Workgroup Consultation			
<h1>GC0151:</h1> <h2>Grid Code Compliance with Fault Ride Through Requirements</h2> <p>Overview: A letter issued by the ESO on 7th May 2021 and a presentation to be made to the 27th May 2021 GCRP have identified concerns about demonstrating compliance with the Fault Ride Through Requirements in the Grid Code. This proposal seeks to apply a workable, non-discriminatory, legally compliant solution based on Good Industry Practice to address this significant operational concern in an expedited manner.</p>	<h3>Modification process & timetable</h3> <ol style="list-style-type: none"> 1 Proposal Form 23 June 2021 2 Workgroup Consultation 30 July 2021 – 16 August 2021 3 Workgroup Report 01 September 2021 4 Code Administrator Consultation 09 September 2021 – 23 September 2021 5 Draft Modification Report 05 October 2021 6 Final Modification Report 07 October 2021 7 Implementation One working day after Authority Decision 		
<p>Have 5 minutes? Read our Executive summary</p> <p>Have 20 minutes? Read the full Workgroup Consultation</p> <p>Have 30 minutes? Read the full Workgroup Consultation and Annexes.</p>			
<p>Status summary: The Workgroup are seeking your views on t

Figure showing theoretical worst case fault which plant has to be capable of riding through

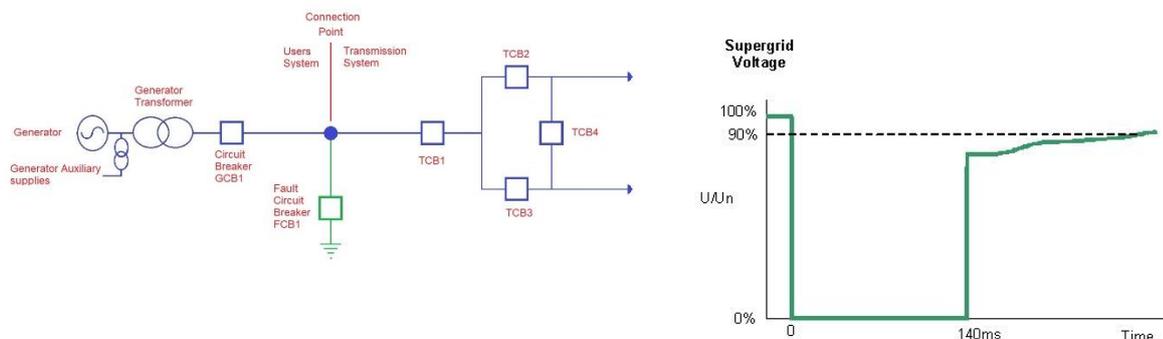
The new section CC.6.3.15(a)(i)(a) will only deal with plant capabilities by clarifying that the plant has to be capable of riding through the worst fault that the network could impose on the plant which is a 3-phase short circuit at the connection point which lasts for 140ms as shown in figure 1 below. To achieve this the words “be design to” will be added to section CC.6.3.15(a)(i)(a) as can be seen in the legal text in appendix *.

Figure 2 showing a fault which can be cleared by transmission system breakers TCB3 & 4

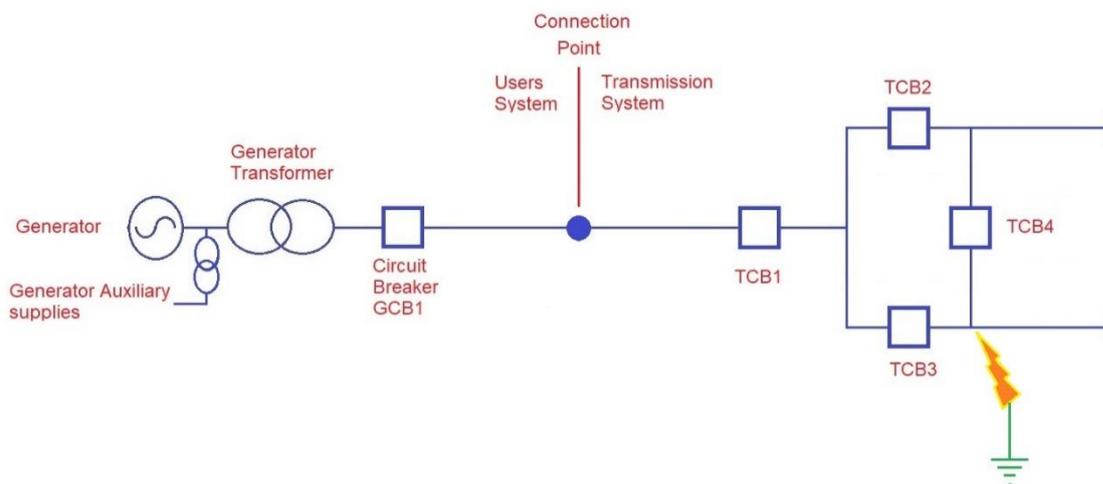
The new section CC.6.3.15(a)(i)(b) shall deal with the actions to be taken in the event that a fault occurs firstly by requiring that plants ride through faults in the transmission

system which can be cleared but transmission system circuit breaker as shown in figure 2 below and by adding the following text as the introduction to the section

(b) Each **Generating Unit, DC Converter, or Power Park Module** and any constituent **Power Park Unit** thereof and **OTSDUW Plant and Apparatus** shall remain transiently stable and connected to the **System** without tripping of any **Generating Unit, DC Converter or Power Park Module** and / or any constituent **Power Park Unit, OTSDUW Plant and Apparatus**, and for **Plant and Apparatus** installed on or after 1 December 2017, reactive compensation equipment, for any balanced and unbalanced fault where subjected to a voltage dip at the **Connection Point** where the voltage remains either on or within the envelope shown in figure CC.6.3.15(a)(i)(a) except where:

Figure 3 showing a fault which can only be cleared by generator breakers GCB1

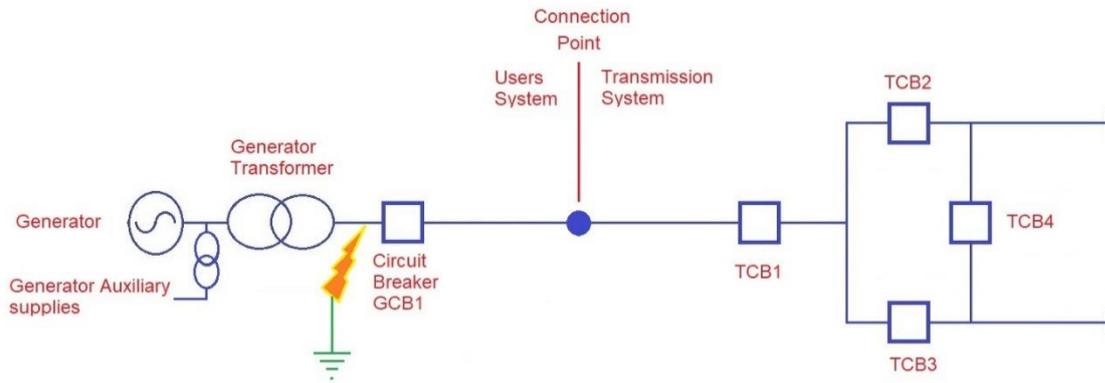
Firstly if the fault is on the generators equipment then the generator shall be required to trip to clear the fault from the transmission system as detailed in the proposed new sections CC.6.3.15(a)(ii)(b)(i) and ECC.6.3.15.8(vi)(i), as follows:-

the fault is on the **User's System**, when the **Generating Unit, DC Converter, or Power Park Module** and any constituent **Power Park Unit** thereof and **OTSDUW Plant and Apparatus** shall trip to clear the fault from the **Transmission System**. The protection schemes and settings should not jeopardise **Fault Ride Through** performance as specified in CC.6.3.15.1

Figure 4 showing a fault which can only be cleared by generator breaker GCB1 & transmission circuit breaker TCB1

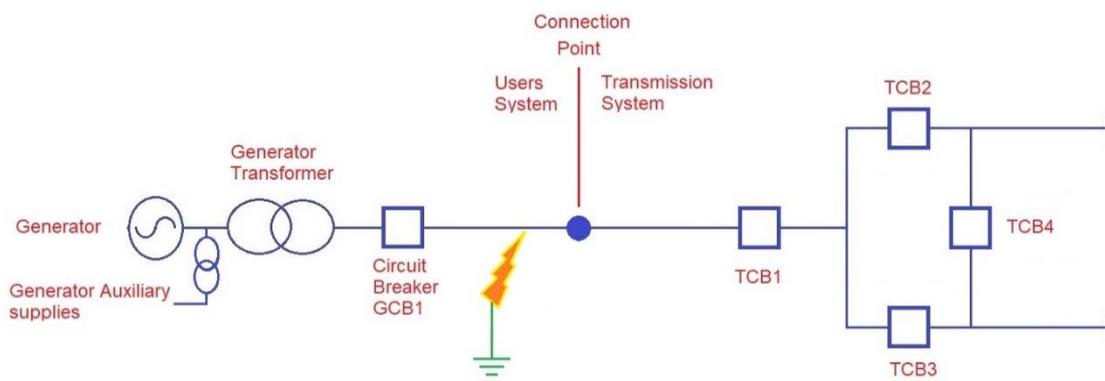
Secondly if the fault is at a location on the network that means that the fault can only be cleared by operation of both transmission and the generator circuit breaker as shown in figure 4, again the generator will be permitted to trip to clear the fault as detailed in the proposed new section CC.6.3.15(a)(i)(b)(ii) and ECC.6.3.15.8(vi)(ii), as follows:-

the location of the fault means it cannot be fully cleared without tripping the of **Generating Unit, DC Converter, or Power Park Module** and any constituent **Power Park Unit** thereof and **OTSDUW Plant** shall trip as required.

Figure 5 showing a fault which can be cleared by transmission breakers TCB1,2&3, however this results in the generator being islanded from the main transmission system and needs to come off

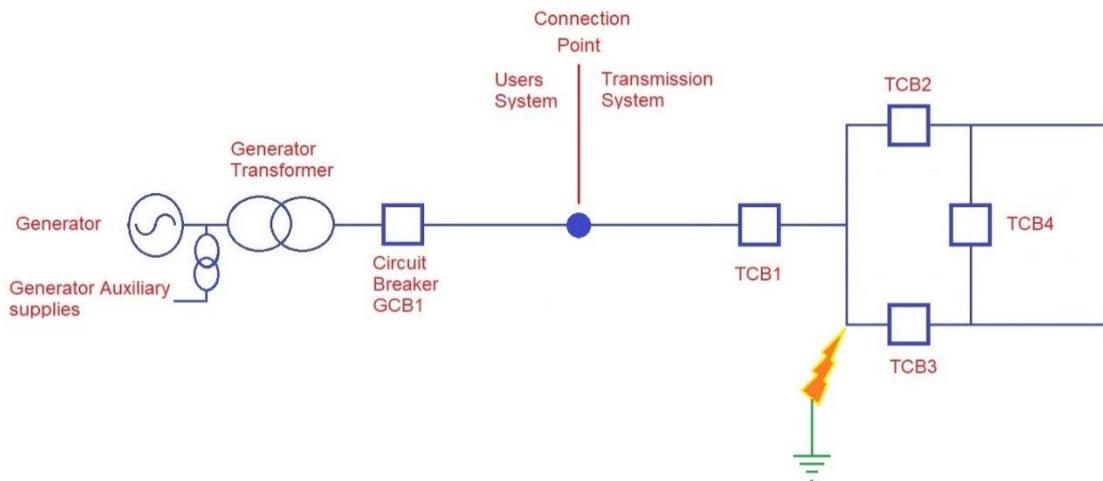
Thirdly if the fault is at a location on the network that means the generator will become islanded by the operation of the transmission circuit breakers as shown in figure 5 as detailed in the proposed new sections CC.6.3.15(a)(ii)(b)(iii) and ECC.6.3.15.8(vi)(iii), as follows:-

clearance of the fault results in the **Generating Unit, DC Converter, or Power Park Module** or **OTSDUW Plant** becoming islanded and disconnected from the **Total System** and not supplying **Customers** (where CC.6.3.7(c)(i) applies), then the **Generating Unit, DC Converter, or OTSDUW Plants** shall be permitted to trip as required.

Figure 7 showing the proposed reactive current injection requirements, requiring the current to always remain above the black line

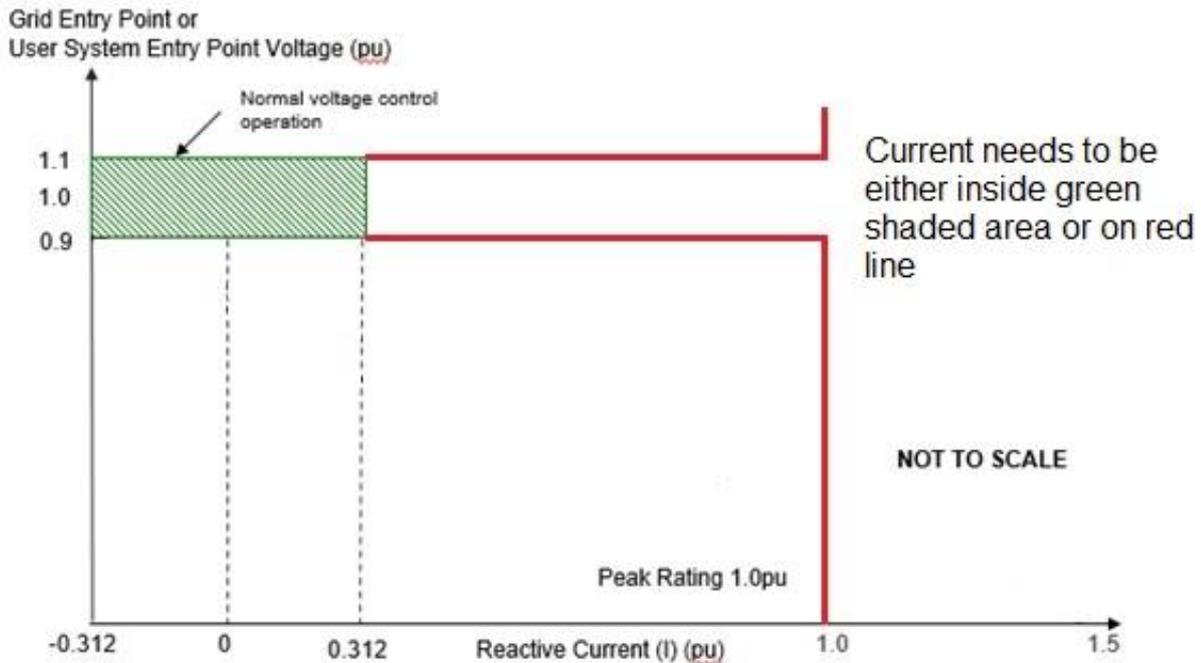
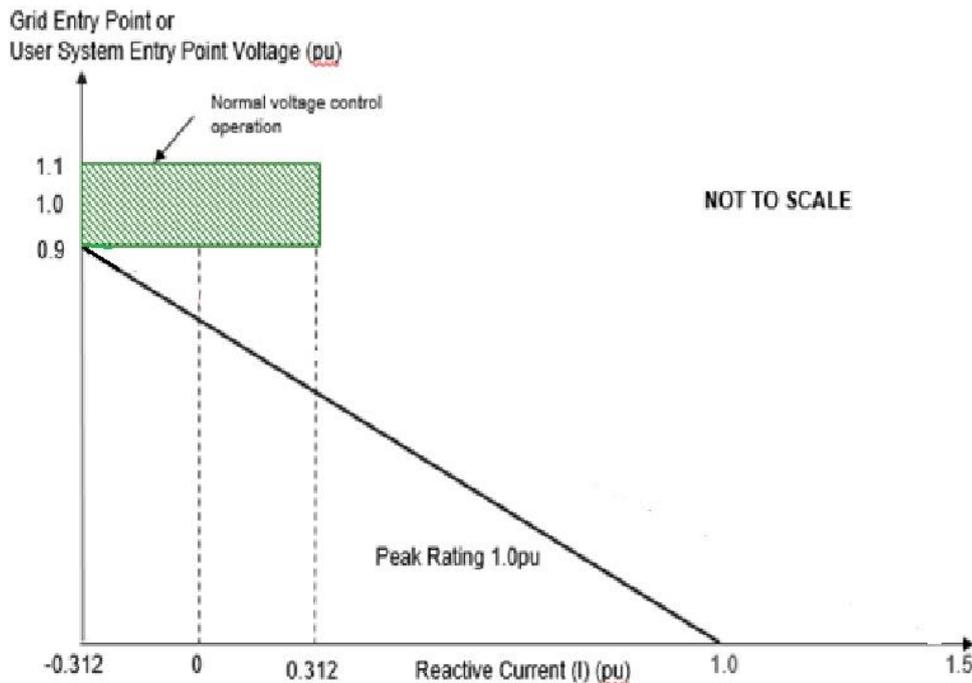
The area of the current legal text which technically creates the biggest problem in relation to the ESO's letter of the 7 May 2021 are in sections CC.6.3.15 (a)(ii) and ECC.6.3.15.9.2.1(a)(i) which currently state "for which the voltage at the Grid Entry Point (or Interface Point in the case of OTSDUW Plant and Apparatus) is outside the limits specified in CC.6.1.4, each Generating Unit or Power Park Module or OTSDUW Plant and Apparatus shall generate maximum reactive current ". If this requirement is drawn out on the figure 6 below where the current and voltage must always either be within the green shaded area or on the red line.

Figure 6 showing an interpretation of the existing legal text requiring the current to either be in the green box or on the red line

This creates a particular problem in relation to the part of the letter which requires Parties to confirm compliance as the Grid Code particularly FRT sections, because as drafted very few plants (if any) actually do this and it has presumably drifted in as a drafting oversight relating to PPM requirements. This issue has previously been identified in the workgroup GC0111 on Fast Fault Current injection and in the GC0137 VSM workgroup and has been fixed for new PPMs, however currently all synchronous generator and older PPM will technically be non-compliant with this FRT requirement as drafted. This issue was dealt with in GC0111 by adding a new figure as shown in figure 7 and changing the text as follows.

- (iv) During the period of the fault as detailed in CC.6.3.15.1 (a) (i) for which the voltage at the **Grid Entry Point** (or **Interface Point** in the case of **OTSDUW Plant and Apparatus**) is outside the limits specified in CC.6.1.4, each **Generating Unit** or **Power Park Module** or **OTSDUW Plant and Apparatus** shall inject a reactive current above the heavy black line shown in Figure CC.6.3.15(b) without exceeding the transient rating limit of the **Generating Unit, OTSDUW Plant and Apparatus** or **Power Park Module** and / or any constituent **Power Park Unit** or reactive compensation equipment.

Figure 8 showing a typical active power response of a unit at low load to a fault

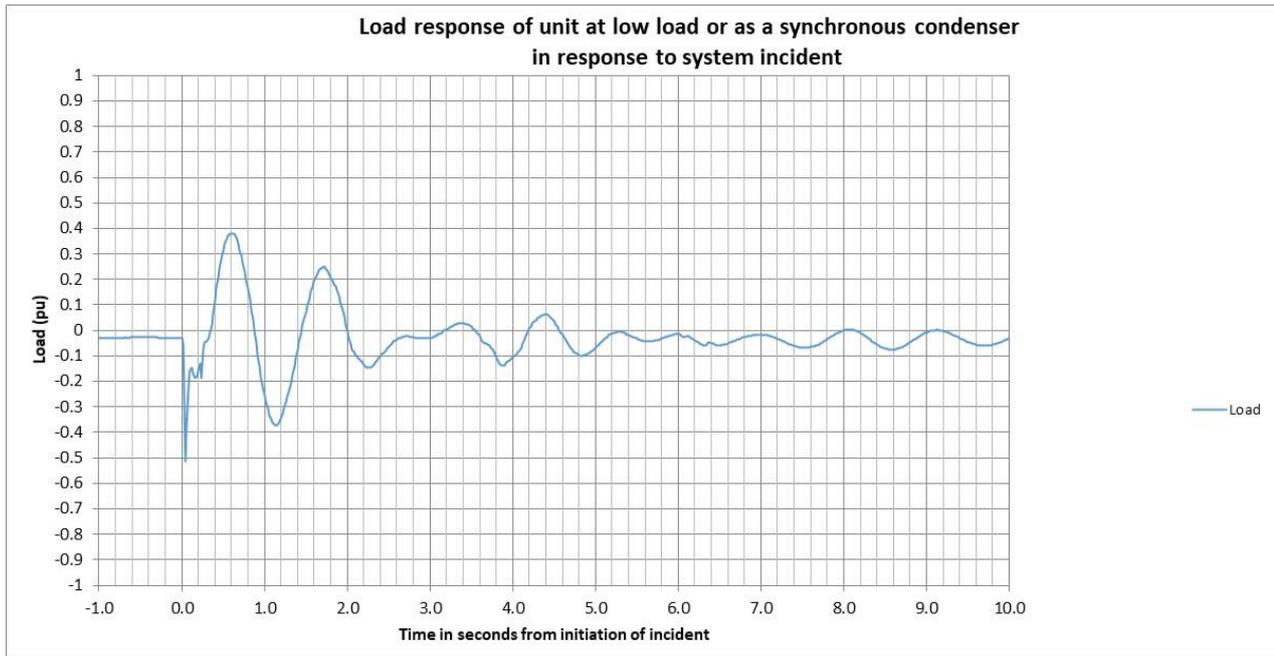
The final area of concern relating to the existing legal text is the minimum active Power requirement after the fault has cleared. Original as drafted the 2005 original as “(or within 0.5 seconds of restoration of the voltage at the **User System Entry Point** to 90% of nominal or greater if **Embedded**), **Active Power** output or in the case of **OTSDUW Plant and Apparatus, Active Power** transfer capability, shall be restored to the level available immediately before the fault”. Subsequently it has been realised that the real response is oscillatory and not very constant so a modification has added the following words
 “- the total Active Energy delivered during the period of the oscillations is at least that which would have been delivered if the Active Power was constant
 - the oscillations are adequately damped of oscillations”

Whilst this works in principle at higher loads it does create an issue at lower loads if you consider at a real event for a unit operating as a synchronous condenser in figure 8.

If you look at the initial load which is 0.02 pu then 90% of this small number you get a very small number, it is also difficult to see how a sensible compliance assessment can be carried out at these levels and it is hence suggested that the tolerance should be changed to 10% of rated capacity as follows
